SERVICE BULLETIN NUMBER 122

TITLE Quik wing keel roll bearing bolt hole cracking and other damage.

CLASSIFICATION The CAA have classified this bulletin as **mandatory**.

APPLICABILITY All Quik Wings up to and including serial no 8184.

Figure 1 Quik Keel Assembly, the hole is where part 18 passes through the keel tube.

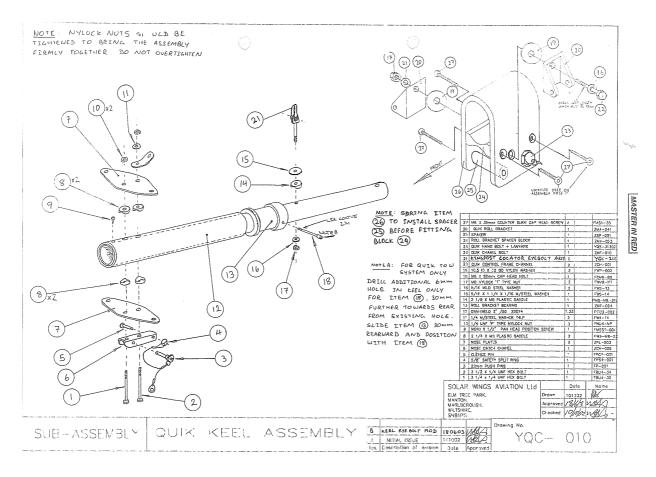
A few Quik wings have been found to suffer from local fatigue cracks in the wing keel at the roll bracket bearing hole (RBBH) where the M6 bolt locates the bearing to the keel. Typically those with cracks have either been training aircraft or subject to a higher than normal number of take offs and landings.

In order to check the wing keel RBBH, the wing needs to be removed from the trike, and the 6mm Cap Head Bolt (item 18, fig1) removed from the Roll Bracket Bearing (item 13, fig1). Remove the nose cone and nose batten. Fold the wing down flat and de-tension it (see operator's manual). Remove the two keel to noseplate bolts and the self tapping screw nose batten locator. This will enable the keel plastic protector tube to be slid forwards (the Leading Edge bolts may have to be slackened to aid removal). Remove the plastic protector tube and cut off 25mm from the rear end.

Slide the roll bearing forwards to expose the RBBH area and inspect using a torch and magnifying glass for elongation, fretting or cracks.

If small cracks, elongation or fretting are detected, with the total damage zone confined to a diameter less than 9mm, the keel can be recovered by incorporating modification M139. Please contact the factory to arrange for the wing/keel to be returned for modification. If more damage is found then the wing keel will need to be replaced with a genuine new factory part. Keel replacement can only be carried out by either factory personnel or experienced wing service centres.

P&M modification M139 has been introduced to reinforce the RBBH area with a 3/8" (9.525mm) interference fit bush tube and additional inner keel sleeve. A damaged area up to 9mm diameter is therefore removed completely. **The keel modification can only be carried out by the Factory.** After fitment the keel must be inspected as part of the existing Quik maintenance manual schedule.

Figure 3
Photo Showing Elongation and Cracks

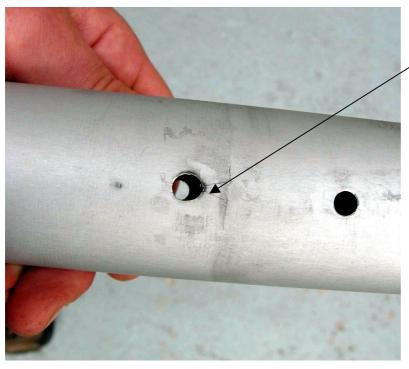
Crack Starts Here Towards Rear Of Keel.
